CERTIFICATE OF APPROPRIATENESS PLACARD

500 N BOUNDARY STREET

070-16-MW

Raleigh Historic Development Commission – Certificate of Appropriateness (COA) Application

Typical fence section (note that spacing will be closer than shown in this image): ✓

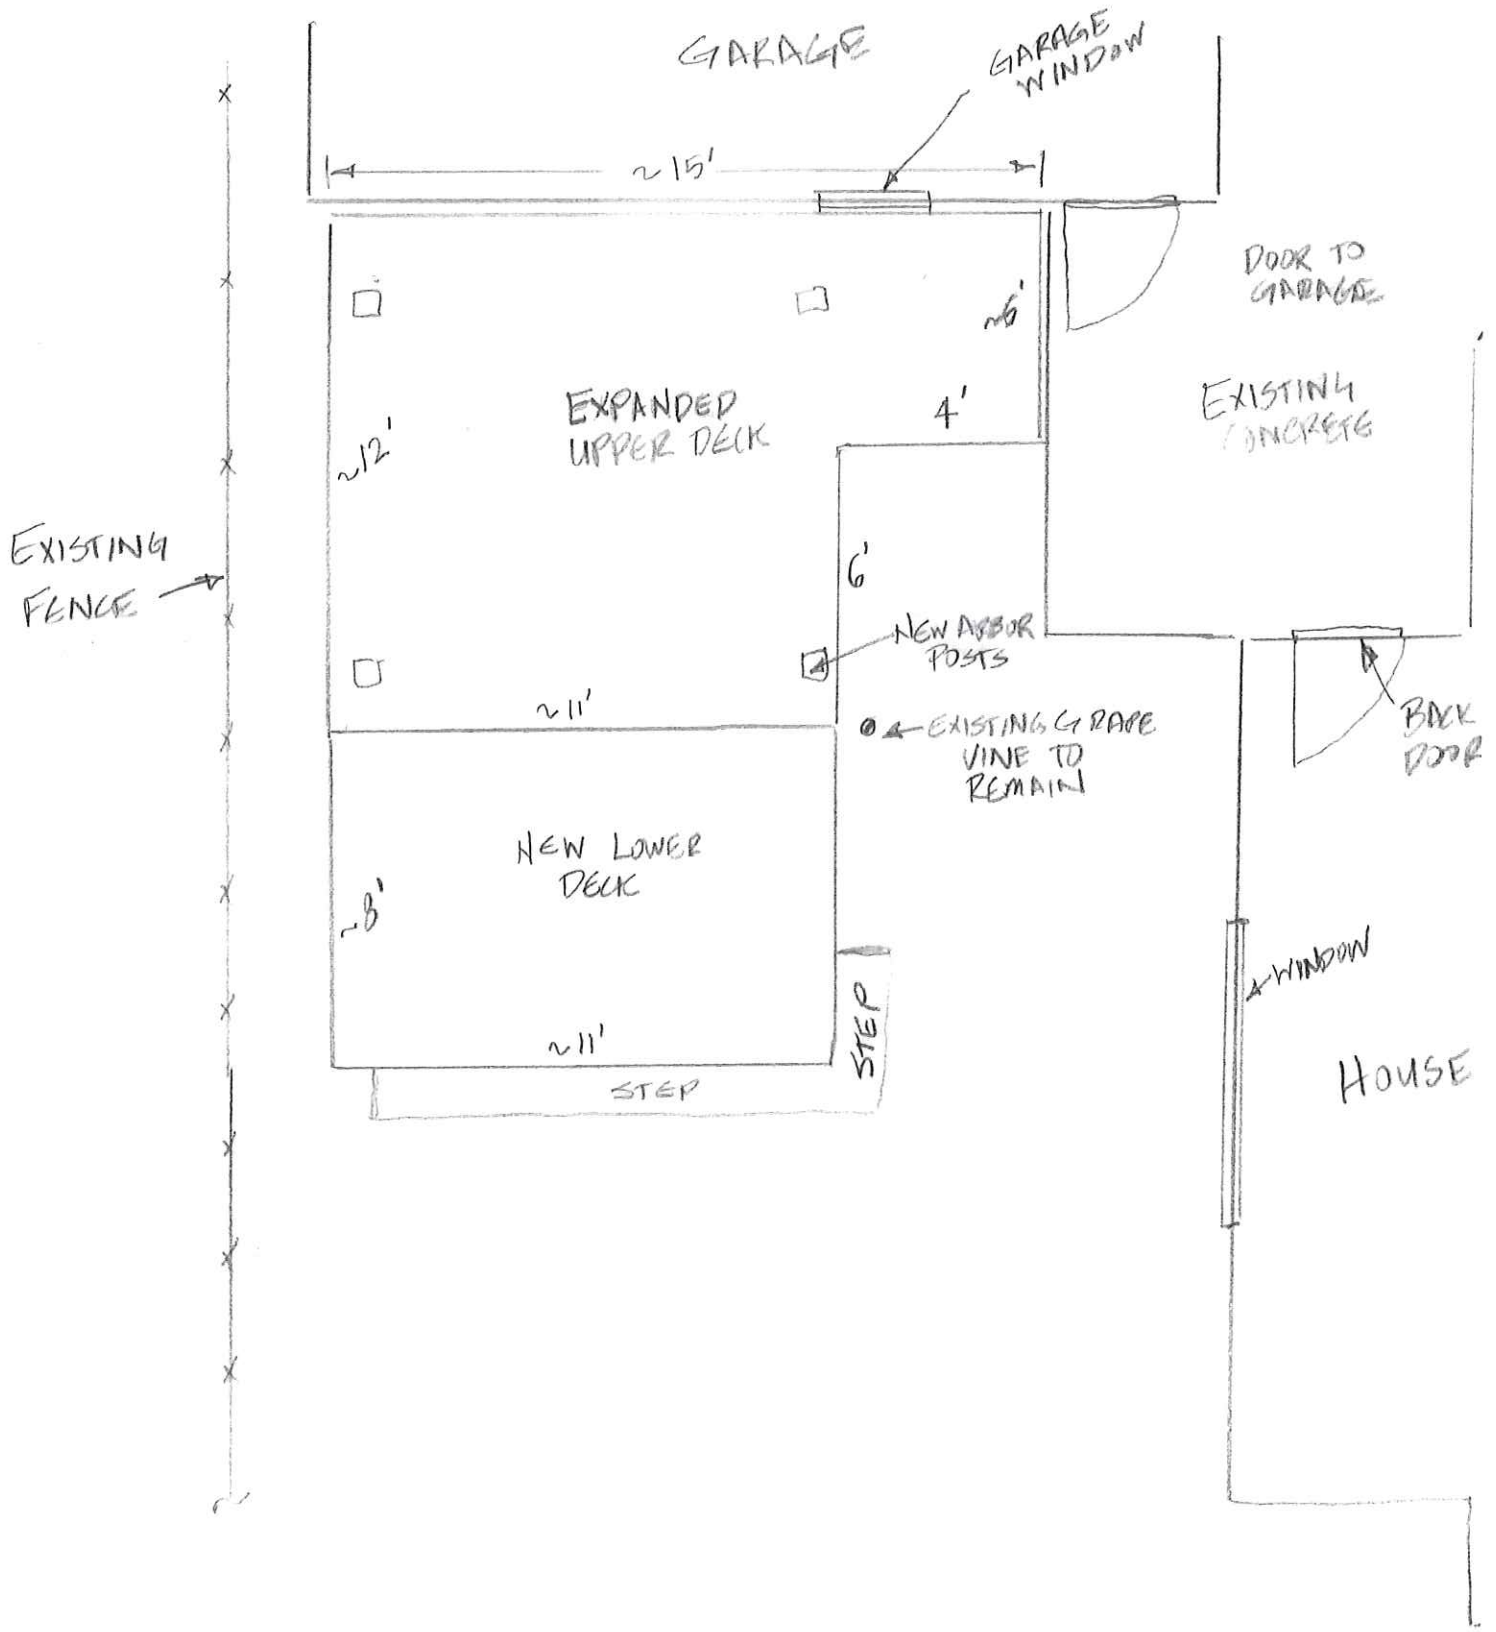
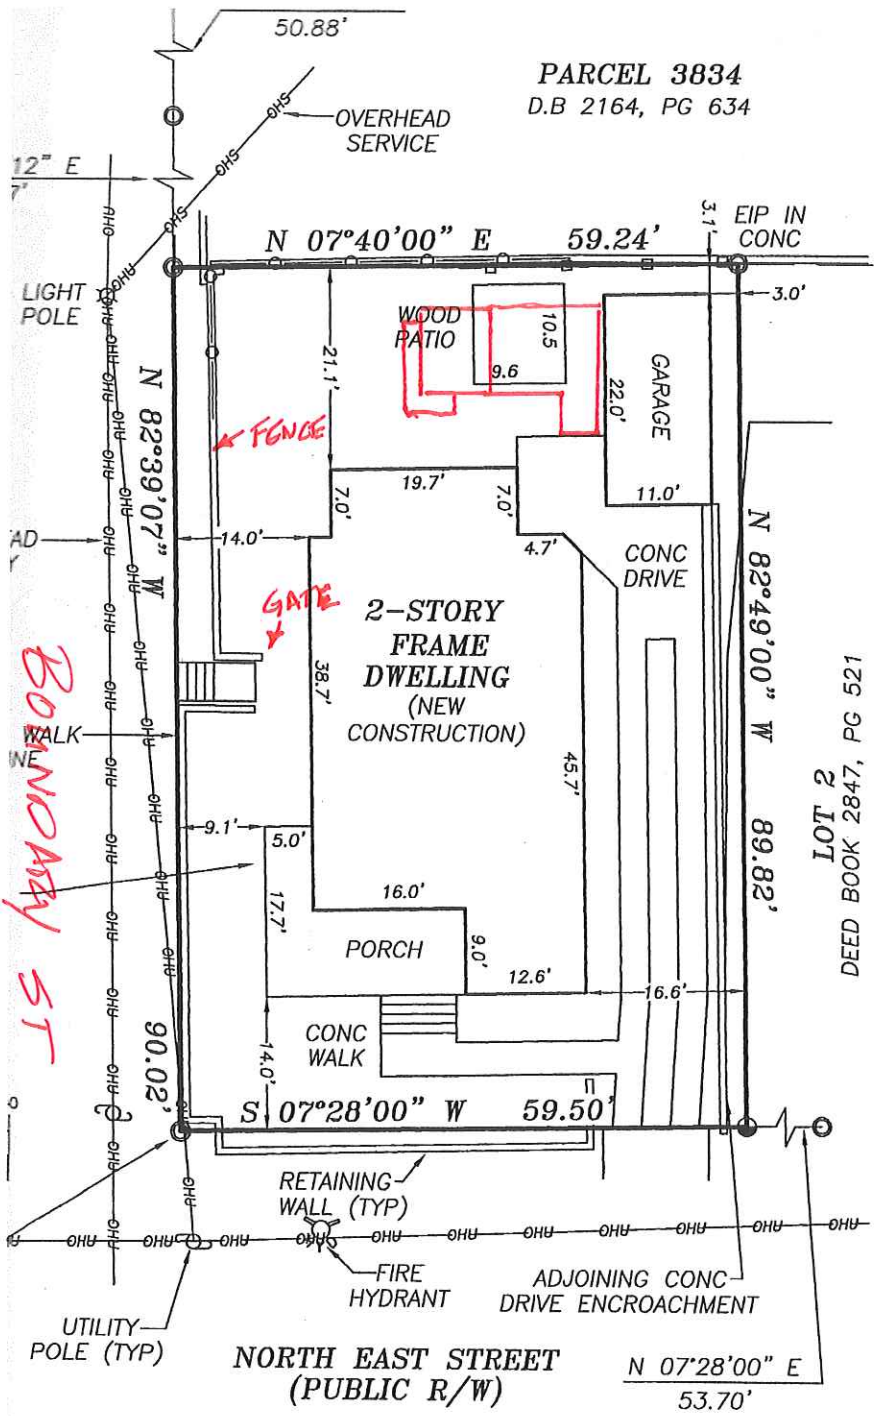
- Please provide photos showing: 1) The front-yard and house taken from each street; 2) The full extent of the deck, preferably from farther back in the rear yard.
 - Please delineate on a site plan, the location of trees greater than 8" DBH whose roots may be impacted by the construction of the fence - Tree roots larger than 1" caliper that are encountered while digging the fence post holes shall receive a clean final cut using tools designed for the purpose, such as loppers. You can go to the following site (<https://maps.raleighnc.gov/iMAPS/>), search for your property, and mark the changes on that and email back.
 - Please provide specific information on the new arbor. A statement of "similar design and dimension" is not a sufficient level of detail.

Daniel - I have attached a Word Doc that has the additional pictures and addresses the questions you had about the arbor. The existing fence is 36" tall and standard chain link. There are no trees with 8" DBH near the fence and the nearest trees in the curb strip along Boundary Street are approximately 3 to 4 feet below the grade of the back yard (and the base of the fence), so there is no risk that any holes dug for fence posts would impact these roots.
